Service Bulletin

Date: **18 February 2022**

Subject: **Steering damper frame bracket kit**

Product: **Superveloce AGO**

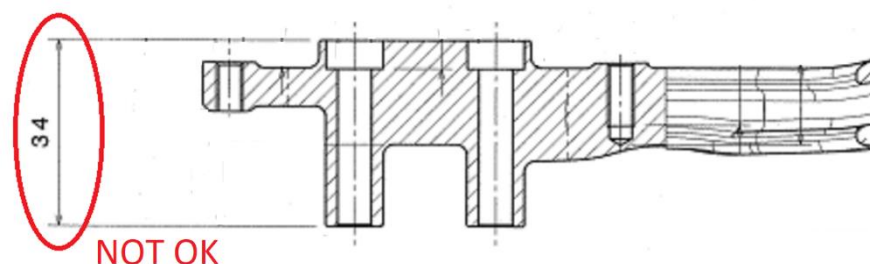
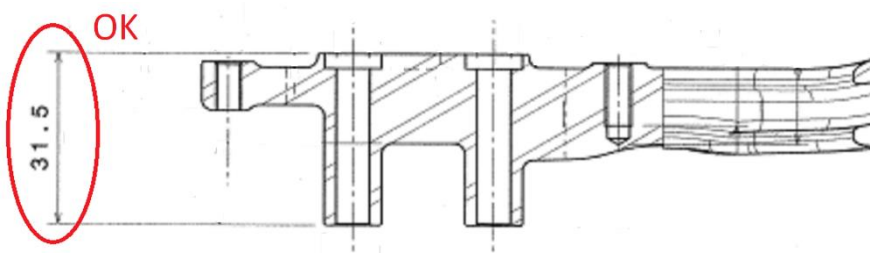
PROCEDURE FOR IDENTIFYING COMPLIANT/NON-COMPLIANT COMPONENTS:

You can check the conformity of the component to be installed by checking the dimension shown in the drawings below. **THE CORRECT DIMENSION is 31.5 mm.**

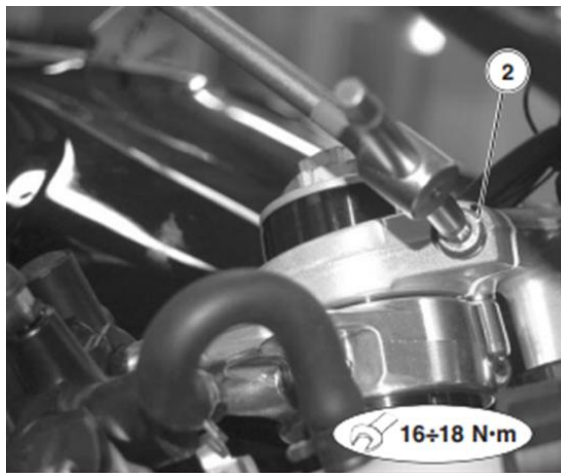
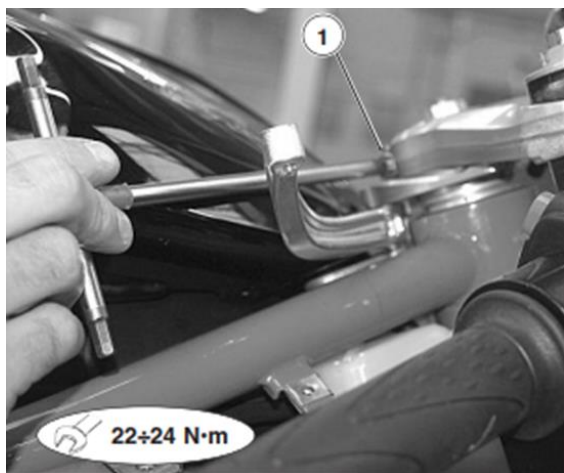
- Undo the two M6 screws and remove the steering damper fixing bracket supplied with the vehicle. **DO NOT re-use the removed steering damper fixing bracket and the two removed M6 screws:**

- Mount the new steering damper fixing bracket code 8000D0201 using the two new screws code 60NDB2740, with a light coat of Loctite 243 on the threads, and tighten at a torque of 8 Nm.
- Position the triple clamp in place, following the removal operations in reverse order, taking care to bring the clamp into contact.
